Cambridge Past, Present & Future
Wandlebury Country Park
Cambridge CB22 3AE
Phone 01223 - 243830
www.cambridgeppf.org

08/07/2022

Response to Cambourne to Cambridge Busway Environmental Impact Assessment - Public Consultation.

Section C - Childerley Gate

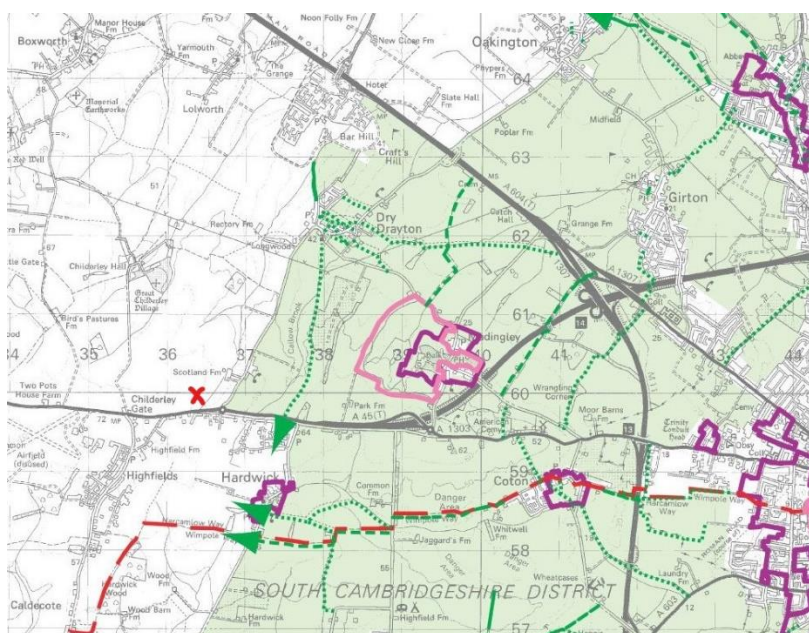
The route through this section would destroy landscaping/habitat that was created to offset the impact of the construction of the A428. There would be a loss in biodiversity.

We wish to raise concerns about the proposal to create an island of new habitats surrounded by busy roads at the eastern section, between the A428, St Neots Road and existing balancing pond. Any wildlife taking up residence here would face the risk of being killed on surrounding major roads and the ecological benefits are likely to be reduced by the physical barriers and ecological severance created by the roads. We are particularly concerned about plans to locate a SUDS pond here, which will attract wildlife and could lead to the deaths of a large number of amphibians attempting to cross busy roads to breed. In our view, this proposal represents poor ecological planning, and we would encourage you to instead consider creating new

habitat in a location which is better connected to other natural habitats and where the wildlife that moves in is not at high risk of being killed. We are aware that there is already a SUDS pond in this location that was created as part of the A428 but we advise you against repeating that mistake.

However, it may be appropriate in this location to plant trees in order to have a mitigating impact on traffic noise and transport infrastructure – as well as some wildlife benefits.

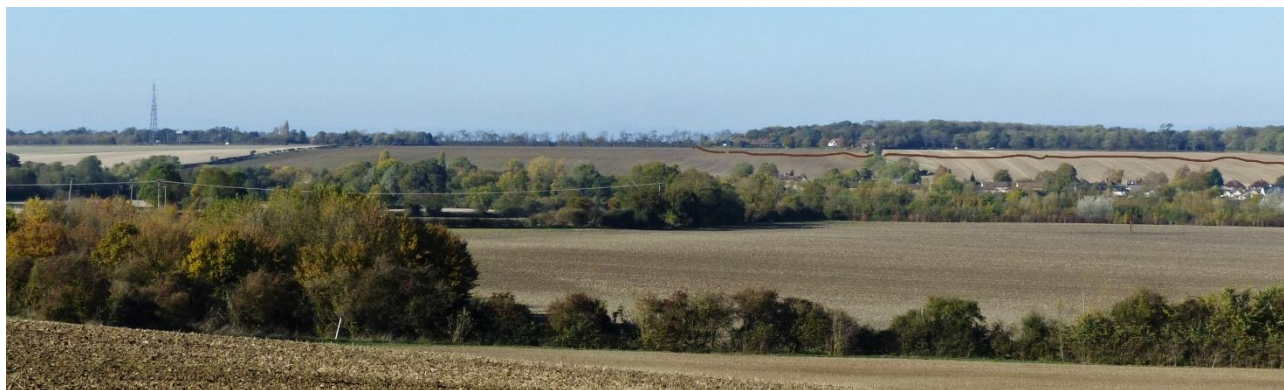
It would be possible to avoid this ecological destruction by delivering an alternative scheme in the A1303 corridor, as we have previously proposed and submitted to you ([click here](#)). This would follow the recommended mitigation hierarchy, which is to:

1. Avoid impact
2. Minimise impact
3. Restore after impact
4. Offset impact
